**AGENDA**  
**CITY OF CEDAR FALLS, IOWA**  
**PLANNING AND ZONING COMMISSION MEETING**  
**WEDNESDAY, FEBRUARY 23, 2022**  
**5:30 PM AT CEDAR FALLS COMMUNITY CENTER, 528 MAIN STREET**

**TO:** Planning Commission  
**FROM:** Michelle Pezley, Planner III  
 Ben Claypool, Civil Engineer II, PhD, EI  
**DATE:** February 15, 2022  
**SUBJECT:** Commercial Site Plan – 3717 Midway Drive (Case # SP22-001)

**REQUEST:** Site plan approval for mini-storage units in C-2 Zoning District  
**PETITIONER:** Gordie Sorensen, Sorensen Real Estate Partners, Inc. (purchase agreement)  
**LOCATION:** 3717 Midway Drive; South of University Avenue; East of the City Limits.

Site Plan Review for Mini-Storage units  
3717 Midway Drive (SP22-001)

DRAWING TYPE  
**NORTH & SOUTH ELEVATIONS**

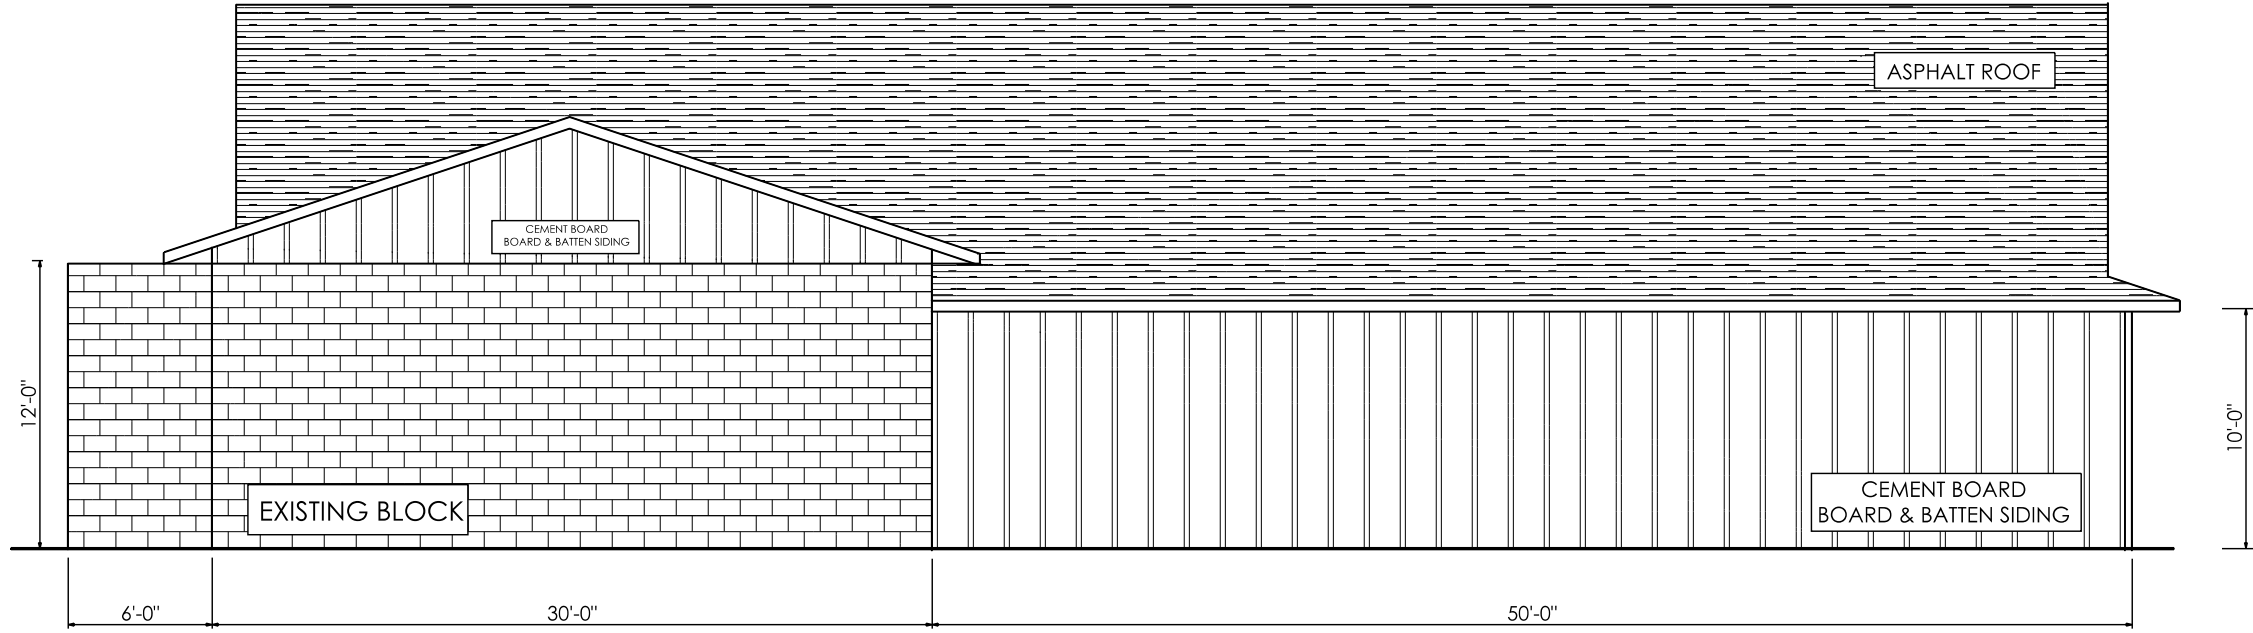
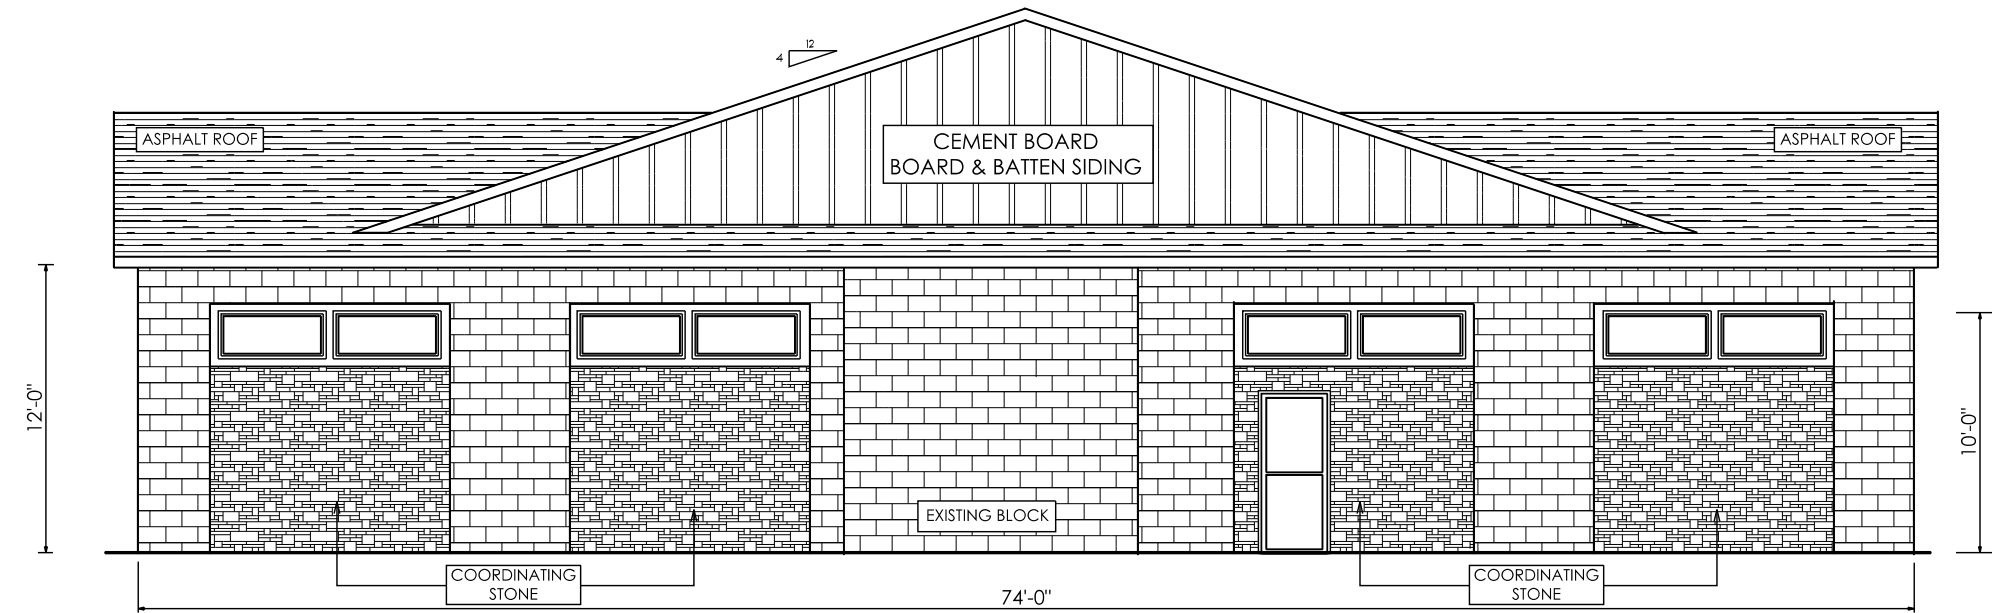
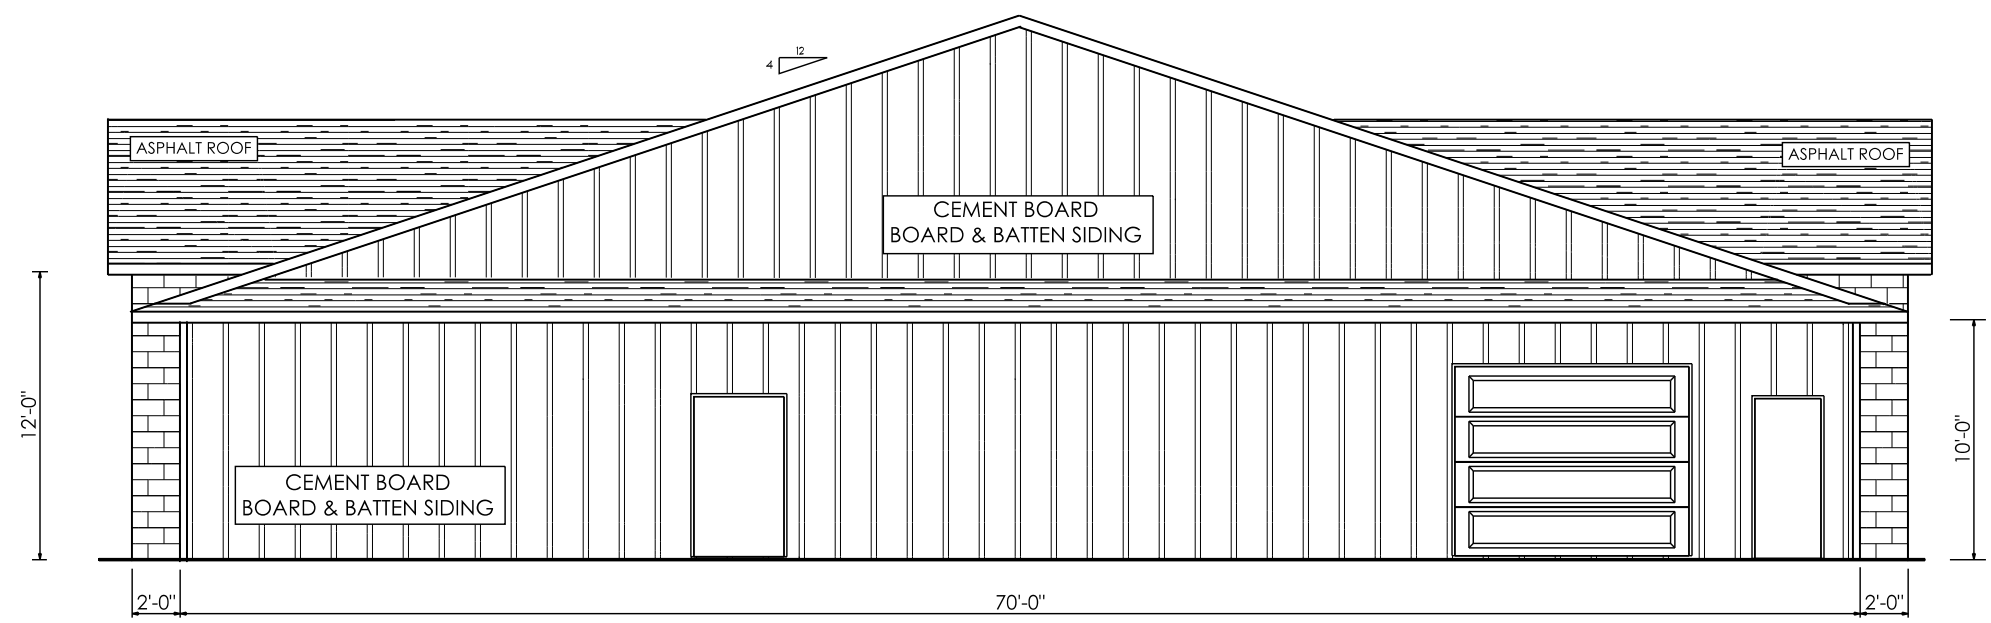
- 4) **Lighting:** The C-2 District regulations do not have specific lighting design guidelines. However, all site plans require a review of the lighting to consider potential nuisance issues and incompatibilities. The applicant proposes to use the existing lighting located on the front facade of the building to light the parking lot. **Lighting is acceptable.**
- 5) **Building Elevations:** As shown on the elevations, the car wash stalls will be enclosed with coordinating stone. The applicant proposes an additional gable in the

front to tie the board and batten siding proposed with the new addition. **Elevations are acceptable.**
